C Q A (W), JABALPUR

PRODUKT 84 mm RCL M2 (84mm ROCKET LAUNCHER) – IN INDIA
NAMN Firing pin फायरिंग पिन

Gf 125089

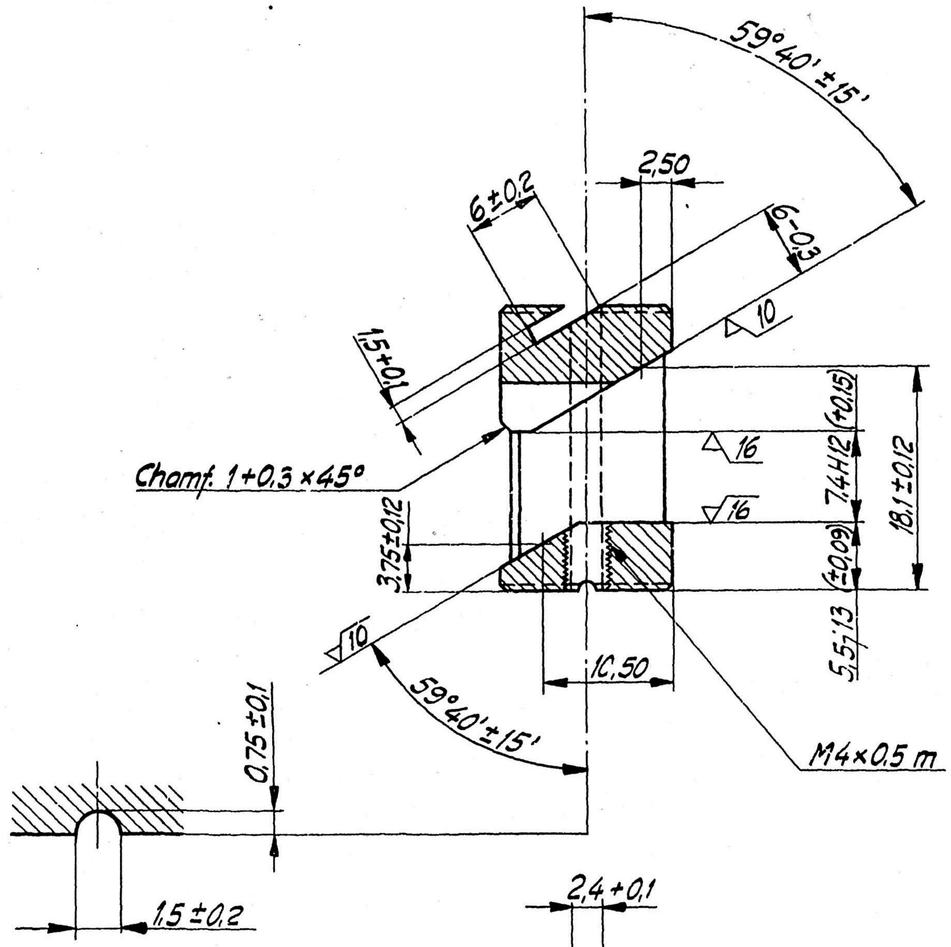
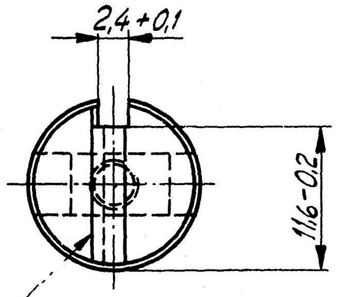
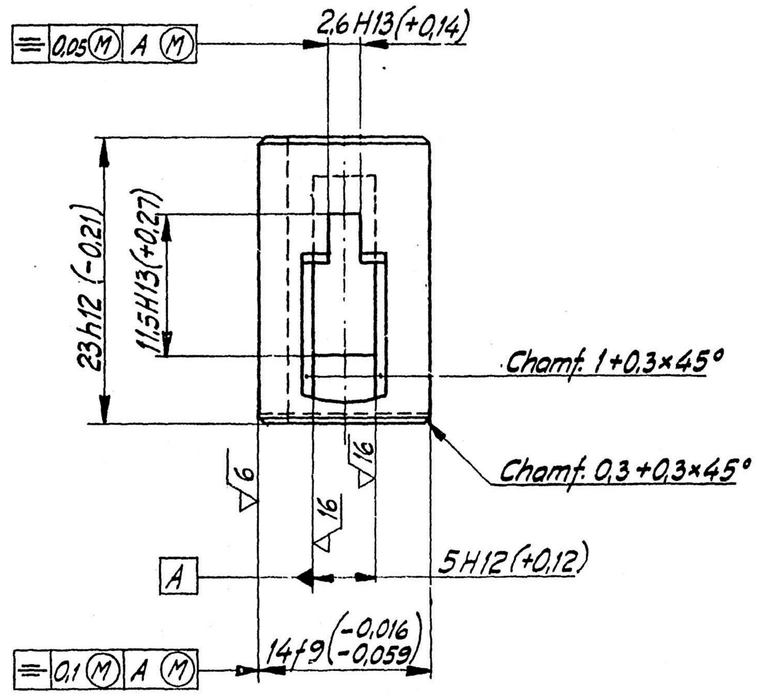
INDIGS SURFACE COATING :-
BLACK OXIDIZING AS PER IS : 11826 ; 86, CLASS ' B '
BLACK OXIDE COATING SHALL ALSO MEET THE REQUIREMENTS AS PER IS : 13212 : 91, CLAUSE 4.3 (FIG IC) IN ADDITION TO REQUIREMENT OF IS : 11826 : 86

16-1-08	19106-W	OLD MATL RESTORED ERRATA TO DC No. 19106-W DT. 16-1-08		
4-8-09		SCANNED & PRINTED WITHOUT CHANGE		
DATE	AUTHORITY	AMENDMENTS	SIG AHSP	SIG DO

MATL IN INDIA : IS : 4072 : 1975 : 70C60R ~~80C60R~~
BS : 970 Pt 5, 070 A72 OR 070A78
